TECHNICAL SERVICE BULLETIN

Technical Service Bulletin: 51-1959

TECHNICAL SERVICE BULLETIN 51-1959 REMEDY INSTRUCTIONS

Subject: RV Door Latch may experience a lock-out condition

Reference - Images of the existing and new designs:

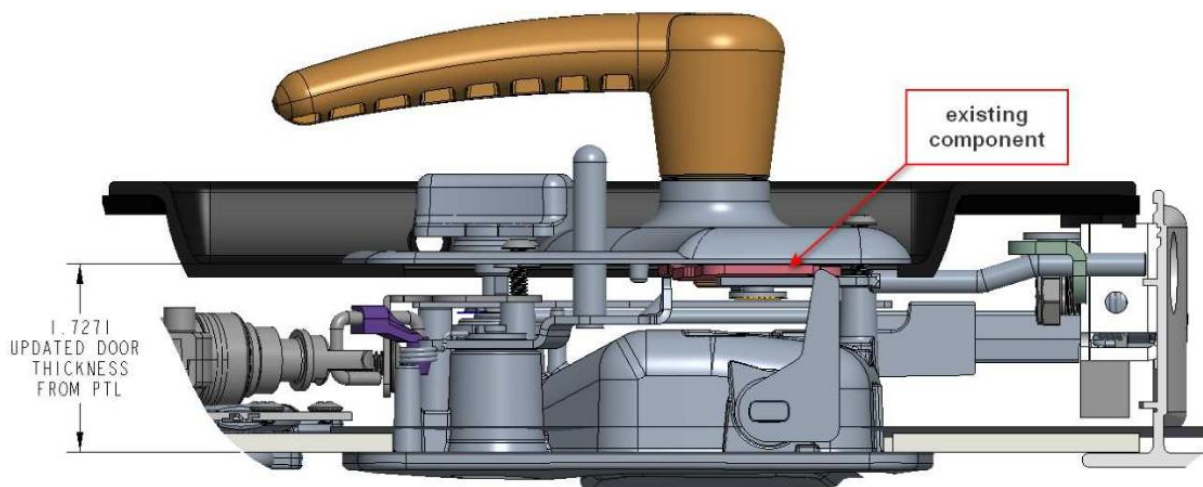
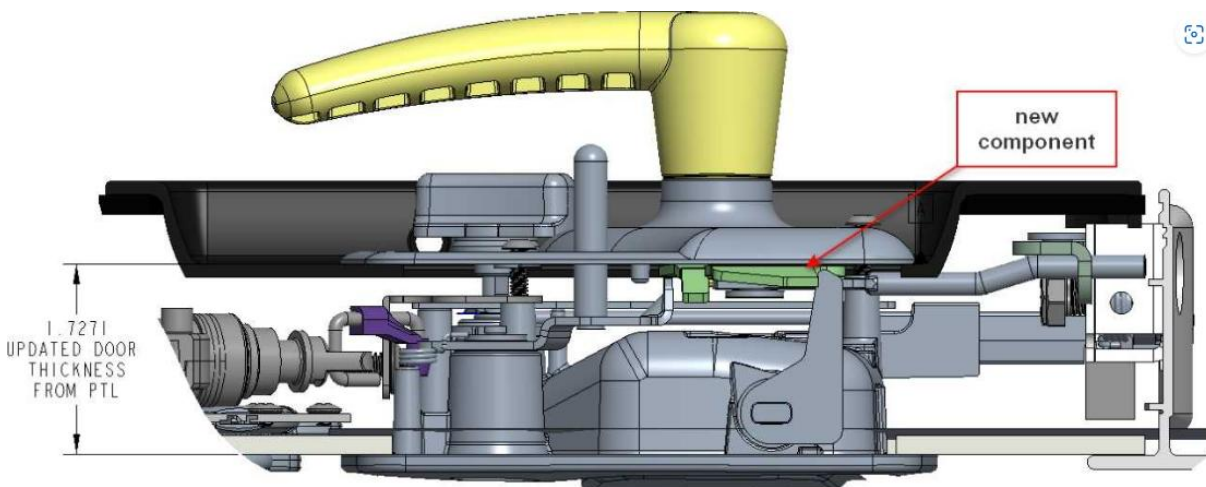
Description of the defect: TriMark manufactured and sold to PTL, a complete RV door hardware system consisting of a 030-0900 Exterior Paddle Handle (P/N's 36285-02 and 36285-04), Inside Release (P/N 21396-05) and Rotary Latch (P/N 17999-01). PTL Engineering has reported that several Motor Coach Manufacturers have encountered issues with motorhome lockouts at their manufacturing facilities. Additionally, there have been several reported lockouts affecting coach owners on sold units. It was found that the pivot arm on the outside handle may pass underneath the release arm of the inside handle, due to multiple potential root causes preventing the door from opening from the outside handle. However, the interior handle is still operational from inside of the motor home.

Description of the safety risk: a small percentage of doors exhibit a condition where the exterior paddle handle can bypass the inside release pivot causing a lock-out situation, but the door can still be opened from the inside.

Description of program for remedying the defect: TriMark has redesigned the inside release pivot plate to provide more engagement with the pivot arm for PTL Entrance Door Model 3000. PTL has modified the bracket to accommodate with the new hardware. This product update will retrofit with the current exterior paddle handle for the field campaign as well as ongoing production. A manufacturing mark will be included on the adjustment rod of the Inside Release Assembly to serve as a visual indicator of revised Product for field identification.

Reference - Images of the existing and new designs:

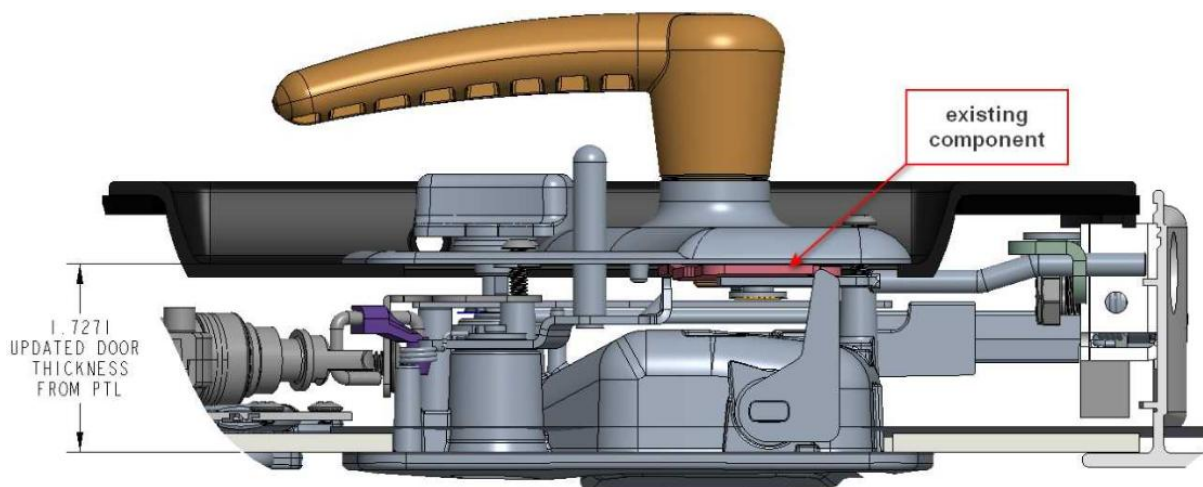
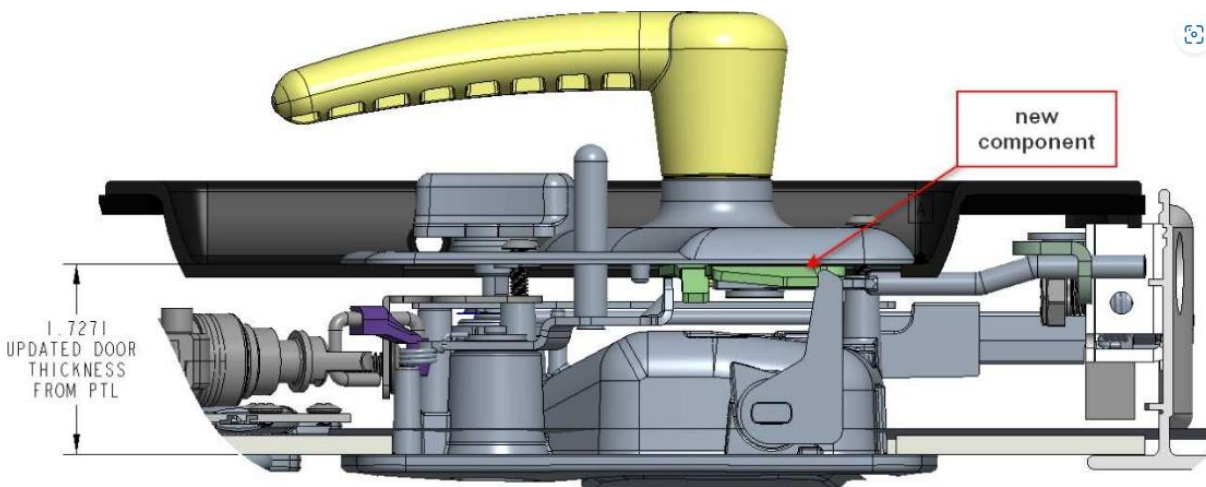
Description of the defect: TriMark manufactured and sold to PTL, a complete RV door hardware system consisting of a 030-0900 Exterior Paddle Handle (P/N's 36285-02 and 36285-04), Inside Release (P/N 21396-05) and Rotary Latch (P/N 17999-01). PTL Engineering has reported that several Motor Coach Manufacturers have encountered issues with motorhome lockouts at their manufacturing facilities. Additionally, there have been several reported lockouts affecting coach owners on sold units. It was found that the pivot arm on the outside handle may pass underneath the release arm of the inside handle, due to multiple potential root causes preventing the door from opening from the outside handle. However, the interior handle is still operational from inside of the motor home.

Description of the safety risk: a small percentage of doors exhibit a condition where the exterior paddle handle can bypass the inside release pivot causing a lock-out situation, but the door can still be opened from the inside.

Description of program for remedying the defect: TriMark has redesigned the inside release pivot plate to provide more engagement with the pivot arm for PTL Entrance Door Model 3000. PTL has modified the bracket to accommodate with the new hardware. This product update will retrofit with the current exterior paddle handle for the field campaign as well as ongoing production. A manufacturing mark will be included on the adjustment rod of the Inside Release Assembly to serve as a visual indicator of revised Product for field identification.
